DCP/NRC1154  
NSD-NRC-97-5456  
Docket No.: 52-003

SUBJECT: SHIELD BUILDING ROOF DSER OPEN ITEM 3.8.4.4-2

**DSER Open Item 3.8.4.4-2 (OITS # 750)**

Figure 3H.5-6-1 (sheet 2 of 5)  
Shield building roof  
Reinforcement at roof to wall connection

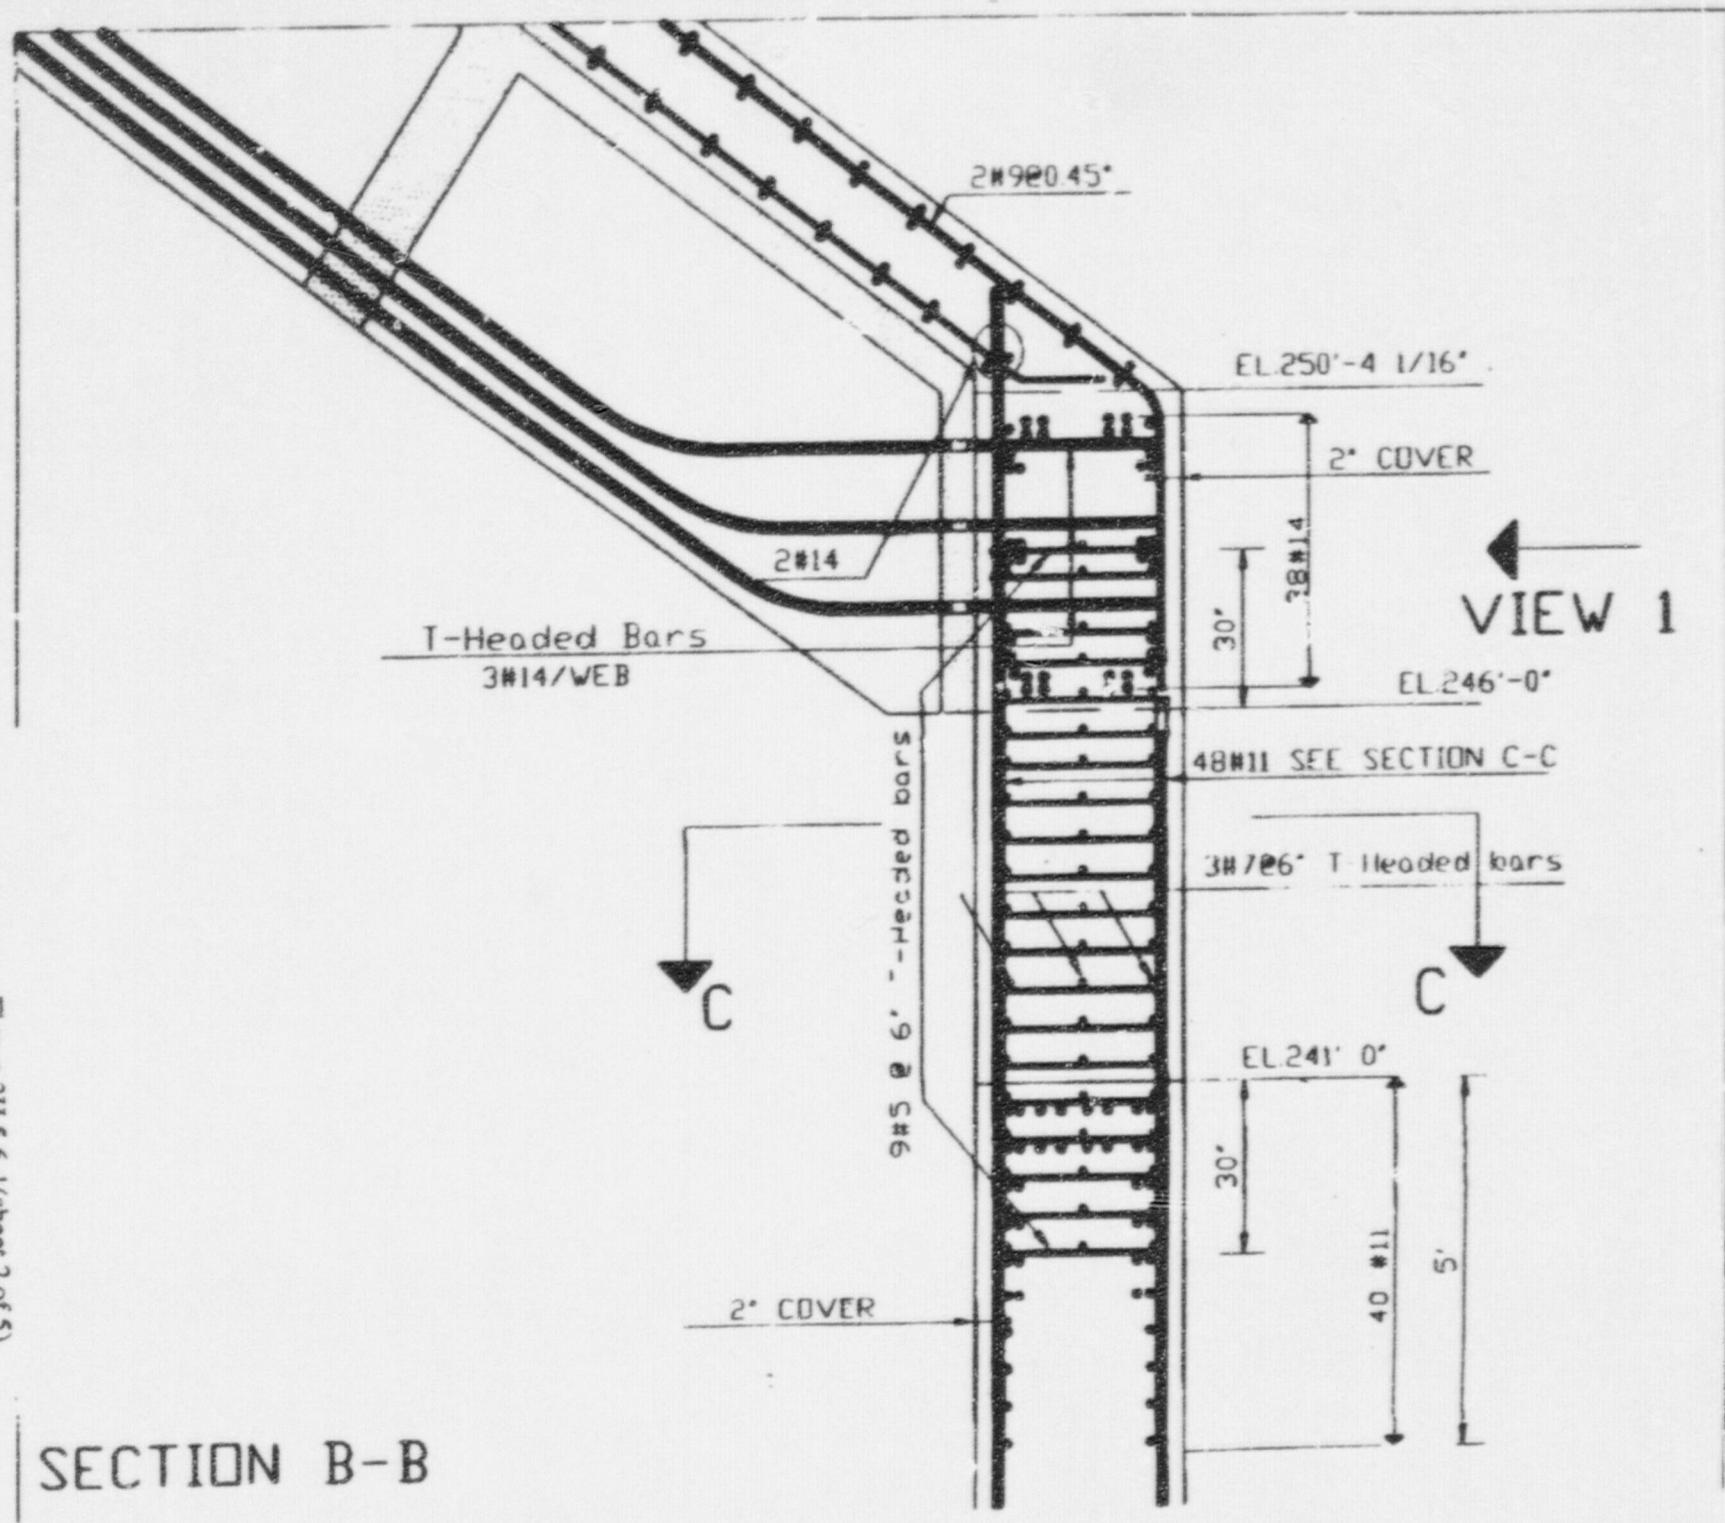
- d) Westinghouse used double-U bars for the hoop reinforcement (or stirrups) at air inlet columns, tension ring beam and compression ring beam to resist shear and torsion (#8 rebar at 6 inches on center for the column, #6 rebars at 4 inches on center for the tension ring beam, and #6 rebars at 12 inches on center for the compression ring beam). In the air inlet columns, Westinghouse did not extend the shear hoop reinforcement (stirrups) and cross-ties above and below the air inlet openings. In the SSAR Westinghouse committed to ACI-318 Chapter 21, which states that stirrups should be provided with 135 degree hooks at both ends of the rebars. The use of double-U bars for the shear reinforcement by Westinghouse does not meet this commitment with their current design."

The tension ring has been reviewed against paragraph 21.3 of ACI 318-95. This is not directly applicable since it applies to frame members proportioned primarily to resist flexure whereas the ring is proportioned primarily to resist axial tension. The reinforcement details shown in sheet 2 of Figure 3H.5.6-1 have been selected as follows:

- Hoop reinforcement meets the requirements of paragraph 21.3.3.6
- Ties have either seismic hooks with a bend not less than 135 degrees or T heads at each end. Use of T heads was described in the Westinghouse letter on basemat issues (NSD-NRC-97-388, dated October 17, 1997).

Figure 3H.5.6-1 (sheet 3 of 5)

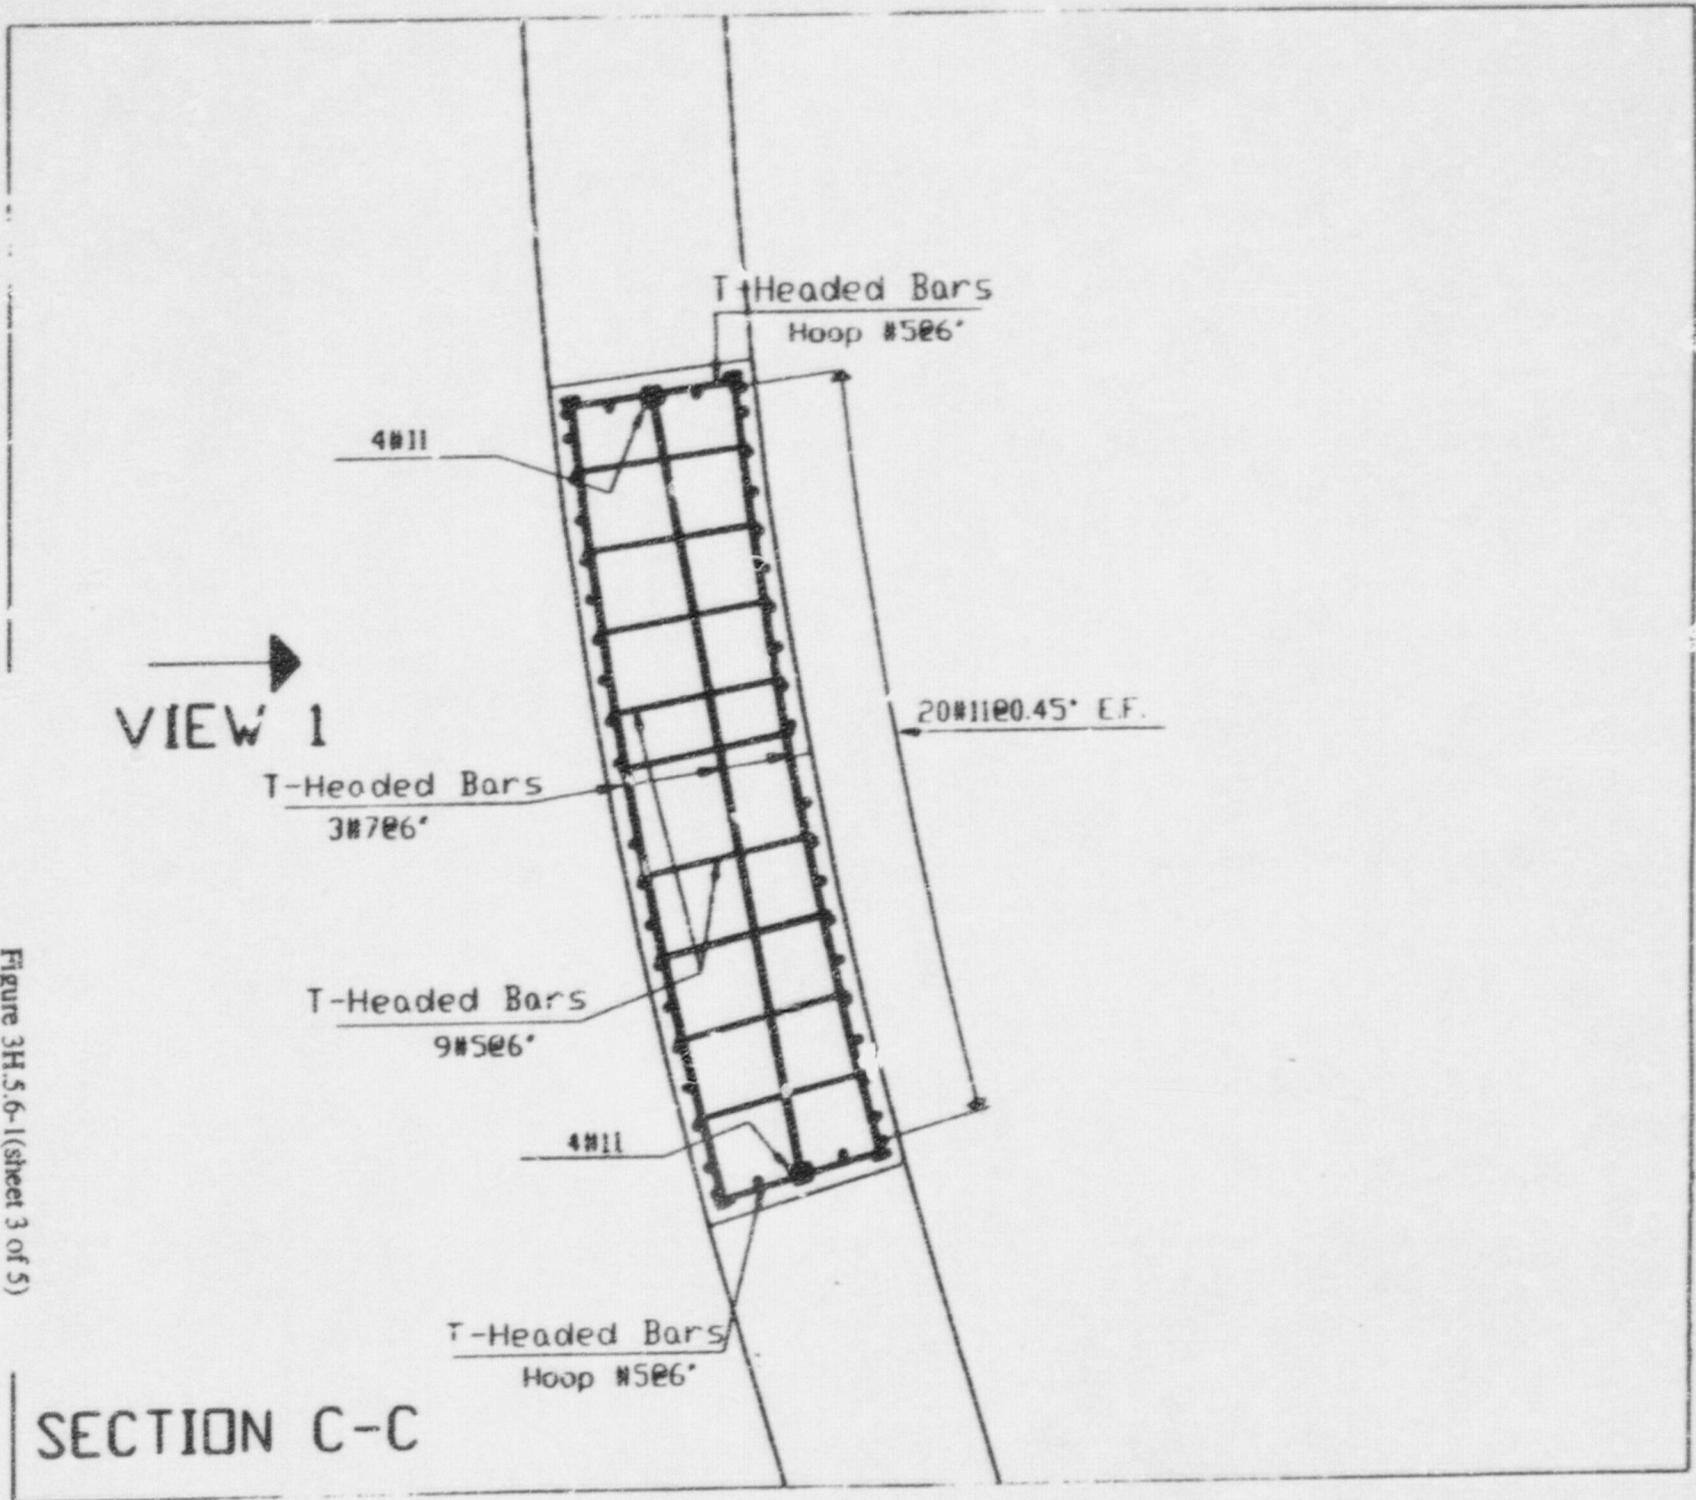
6(b) *The reinforcement drawings do not show the vertical reinforcement in sides of the air inlet columns. The length of these bars should also be provided.*

The lap splices in the double U horizontal reinforcement (#8 bars at 6 inches on center) have been eliminated. The horizontal reinforcement in the shear walls is now provided by T headed bars as shown in sheet 3 of Figure 3H.5.6-1. These T heads act as mechanical anchorage as recommended in the commentary to paragraph 21.6.6.

The column is 36" thick and 60" high. The primary loading is vertical load plus out of plane shear. The out-of-plane shear is smaller than the in-plane shear since the horizontal seismic loads are resisted primarily by in-plane shear in the cylindrical wall. The out-of-plane loads are caused by the deformation of the tension ring and do not contribute significantly to the lateral load resistance. The column was evaluated against the provisions of paragraph 21.6. Out-of-plane shear is resisted by through wall T headed ties as shown in sheet 3 of Figure 3H.5.6-1.

This vertical reinforcement is the reinforcement at the end of the columns adjacent to the air inlet openings. It was shown on the reinforcement drawings. The drawings have been revised to clarify this reinforcement and to show the length. The length of the bars in the middle of the wall is the height of the opening plus development length above and below the opening.
